CITY OF CODY  
PLANNING, ZONING, AND ADJUSTMENT BOARD  
TUESDAY SEPTEMBER 24, 2019  
CITY HALL COUNCIL CHAMBERS @ 12:00 NOON

**CITY OF CODY  
PLANNING, ZONING AND ADJUSTMENT BOARD  
STAFF REPORT**

**CITY OF CODY  
PLANNING, ZONING AND ADJUSTMENT BOARD  
STAFF REPORT**

<b>MEETING DATE:</b>	SEPTEMBER 24, 2019	<b>TYPE OF ACTION NEEDED</b>	
<b>AGENDA ITEM:</b>		P&Z BOARD APPROVAL:	
<b>SUBJECT:</b>	CONCEPT PLAN REVIEW OF THE CODY LEGACY ESTATES PLANNED UNIT DEVELOPMENT. PUD 2019-01	RECOMMENDATION TO COUNCIL:	
<b>PREPARED BY:</b>	TODD STOWELL, CITY PLANNER	DISCUSSION ONLY:	X

SITE PLAN

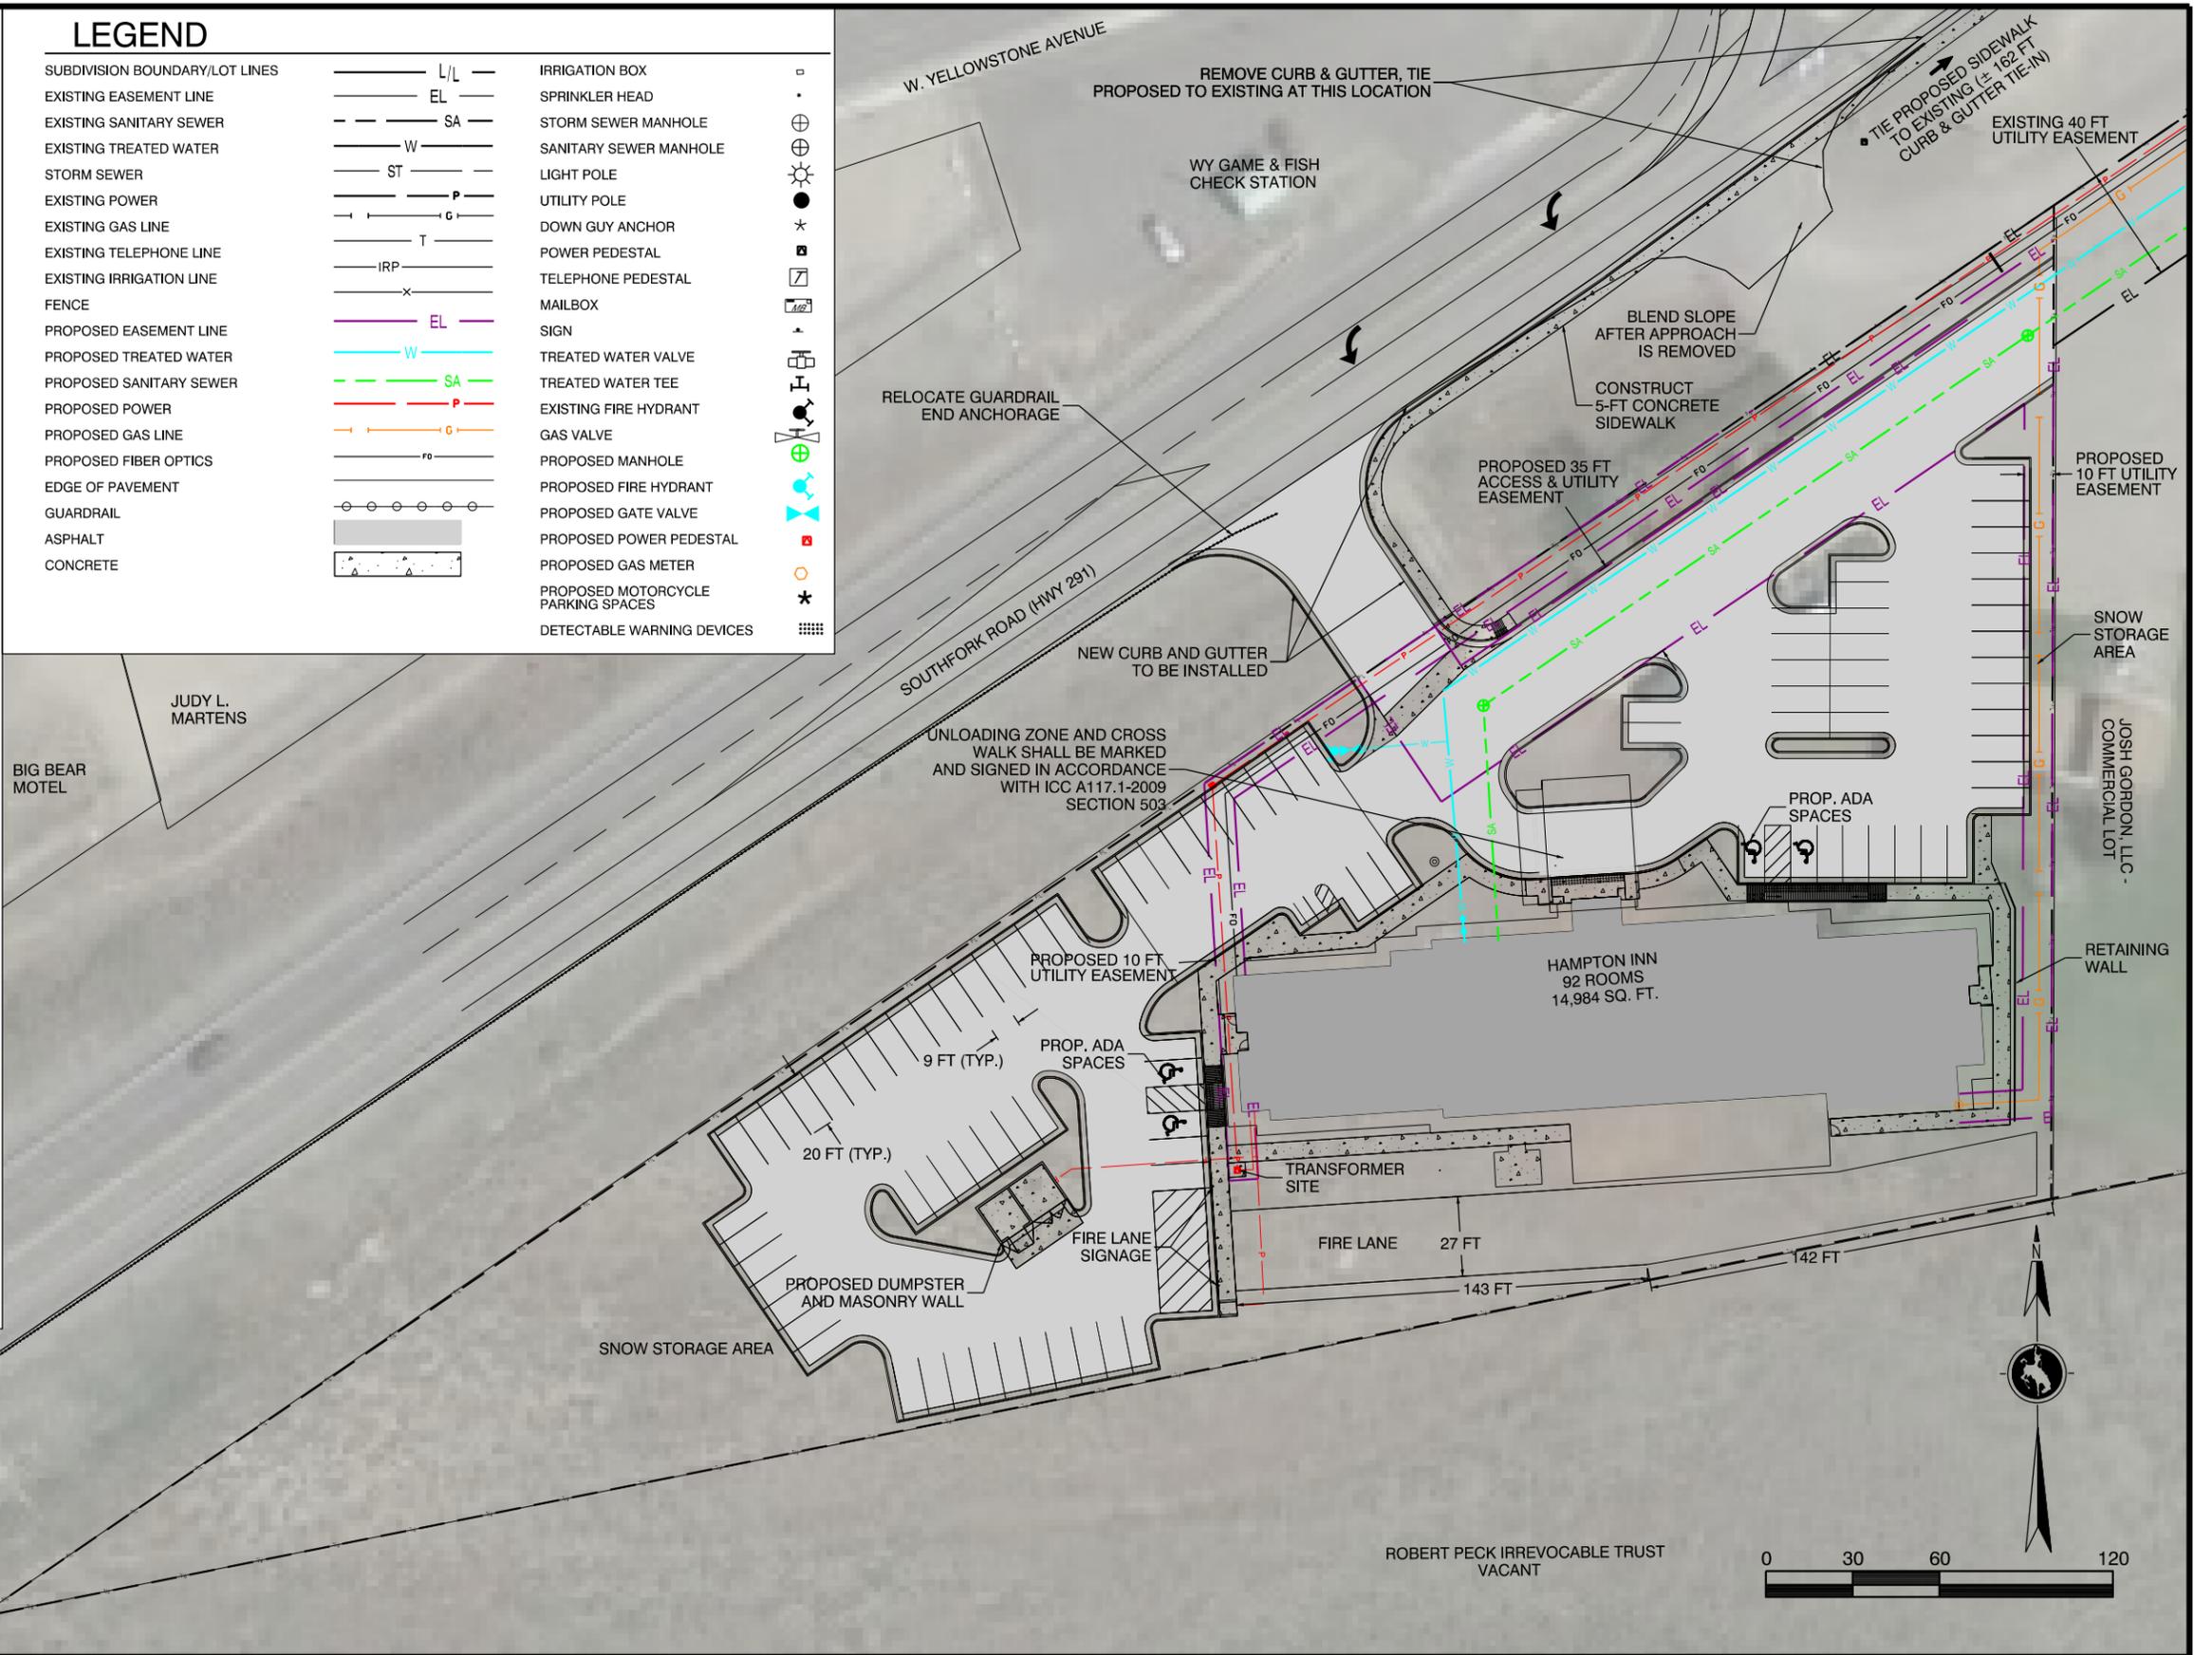
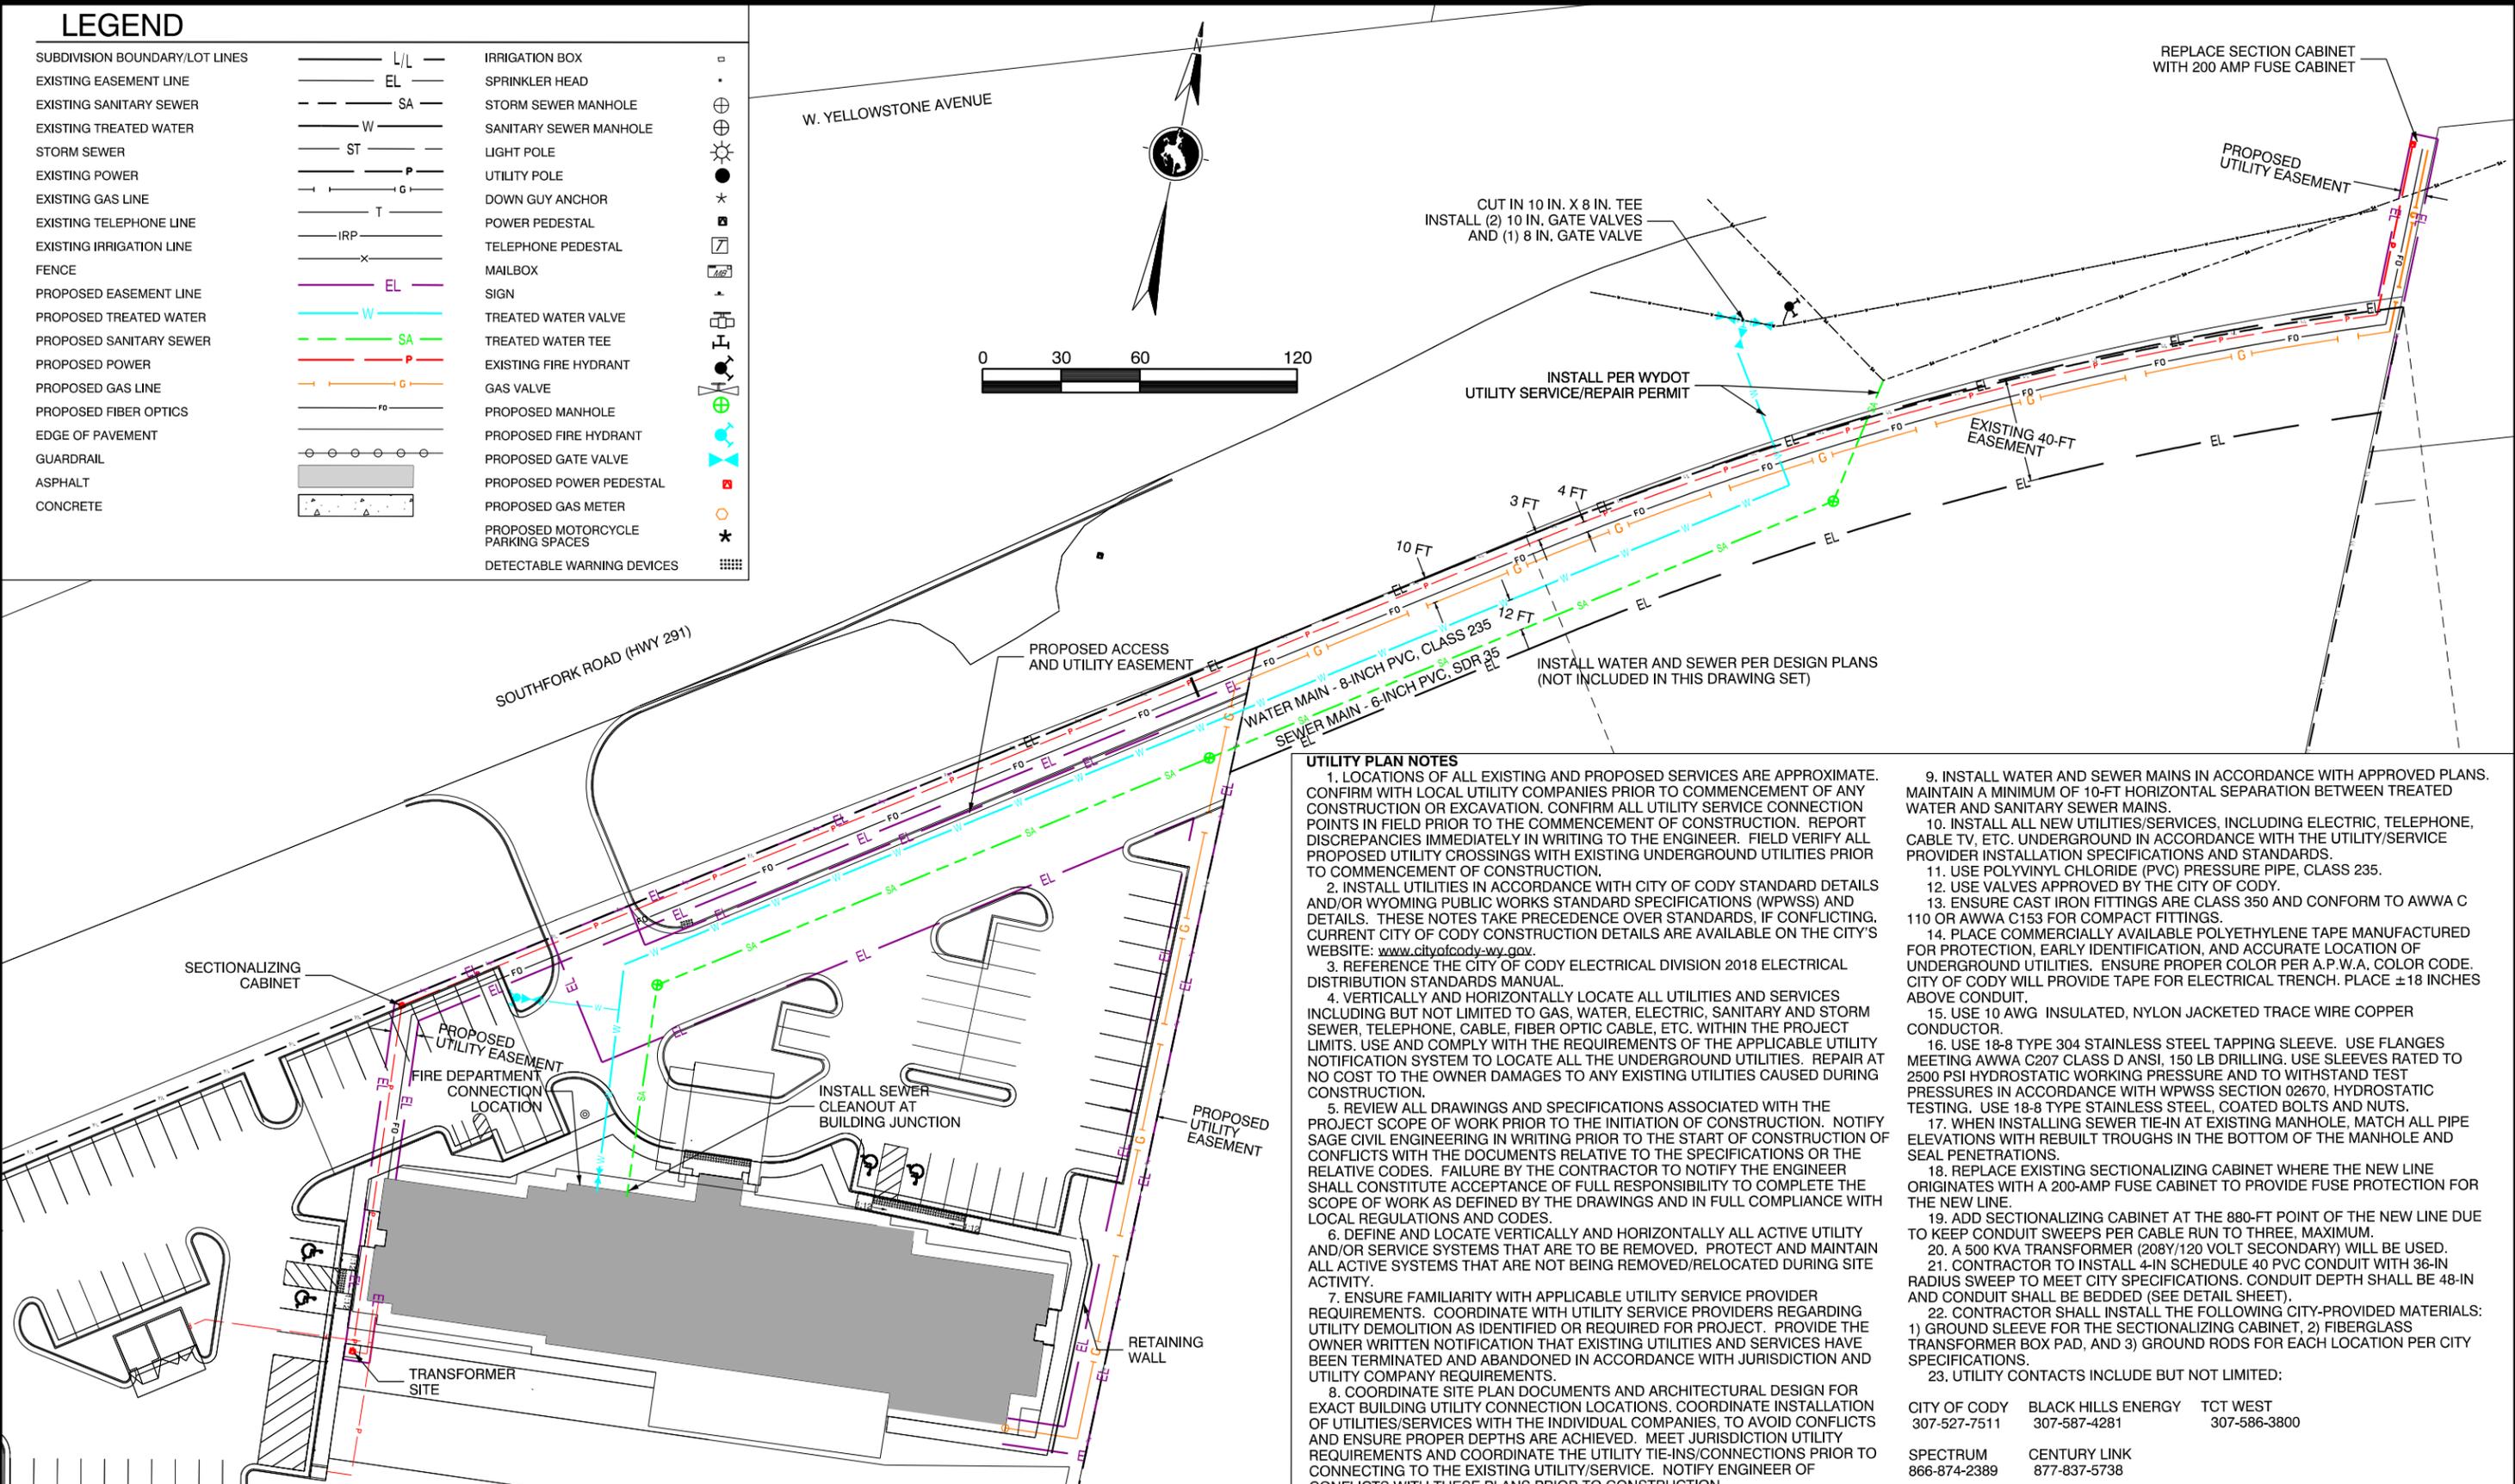
The revision to the site plan removes all parking along the north boundary of the property that is east of the approach, reconfigures the parking in the island north of the hotel entrance so that no vehicles back into the easement, and due to the reduction in total spaces, reduces the number of ADA parking spaces from six to four. What was a 29-foot wide aisle through the parking lot would now be a 35-foot wide frontage road. The portion of the former parking space area not utilized by the frontage road would be landscaped.

The approved site plan has 112 standard spaces shown, six of which are ADA spaces. An additional six motorcycle spaces were also shown.

The revised site plan has 93 standard spaces, four of which are ADA spaces. Three additional motorcycle spaces are also shown. (Motorcycle spaces have not historically been counted towards the number required.)

While Planning Staff prefers the approved site plan, we are also agreeable with the proposed changes to the site plan and resulting reduction to 93 parking spaces. It is noted that the proposed modification to the site plan is due to demands from the adjacent property owner, and the Hampton Inn developer is attempting to be accommodating as a good neighbor.

Staff recommends approval of the revised site plan subject to the following condition. All conditions from the September 10, 2019 approval otherwise remain in effect.

1. Provide updated drainage, landscaping, and lighting plans to reflect the modifications to the site plan. The additional landscaping shall correspond with the rest of the landscaping. Staff is authorized to review and approve the plans as part of the building permit review process.
